STATE OF CALIFORNIA CALIFORNIA NATURAL RESOURCES AGENCY DEPARTMENT OF WATER RESOURCES DIVISION OF SAFETY OF DAMS

INSPECTION OF DAM AND RESERVOIR IN CERTIFIED STATUS

Name of Dam	San Joaquin Reservoir		Dam No1029	Dam No. 1029 County		Orange		
Type of Dam	Earth			Type of Spillway	Drop Inlet			
Water is	1.3	feet	below	spillway crest and	6.8	feet	below	dam crest.
Water Surface Elevation El. 469.2'								
Weather Conditions Sunny								
Contacts Made Danielle Drake and Bill Wesson with IRWD								
Reason for Inspection Periodic Maintenance Inspection

Name of Dam San Joaquin Reservoir	Dam No.	1029
	Date of Inspection	4/18/2023

Photo 2: View of the erosion rill on one of the downstream benches.

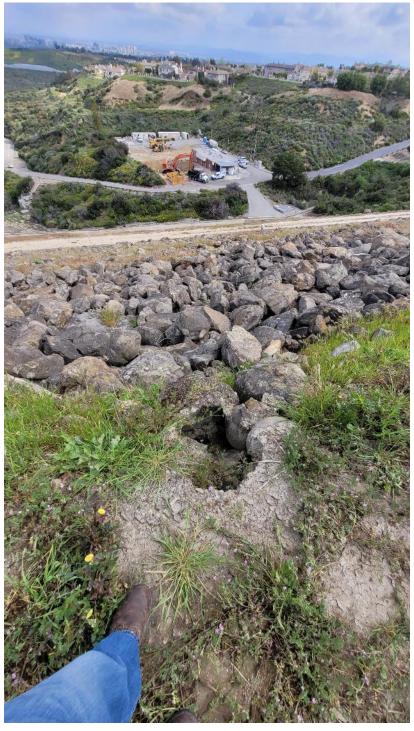
The crest appeared level and well-aligned. Overall, the asphalt-lined upstream slope, and the earthen downstream slope appeared uniform, stable, and in satisfactory condition. There is some minor erosion on one of the benches on the downstream slope. The owner needs to backfill and compact erosion rills as they appear as an ongoing maintenance item. The groins, downstream toe, and abutments appeared satisfactory with no signs of instability or distress. The vegetation is well managed with periodic vegetation control from the owner. The rodent control is satisfactory with no signs of rodent activity.

- The owner needs to continue the following as ongoing maintenance items:
 - Backfill and compact erosion rills as they appear.
 - Maintain the pneumatic piezometers to ensure accurate readings.
- For future instrumentation reports, the owner needs to complete the following:
 - Rain data needs to be incorporated into the piezometer data plots.
 - o Ensure that the field data and the report data match in regard to the Floor seepage point.
- The owner will need to fully cycle all valves during the next maintenance inspection.
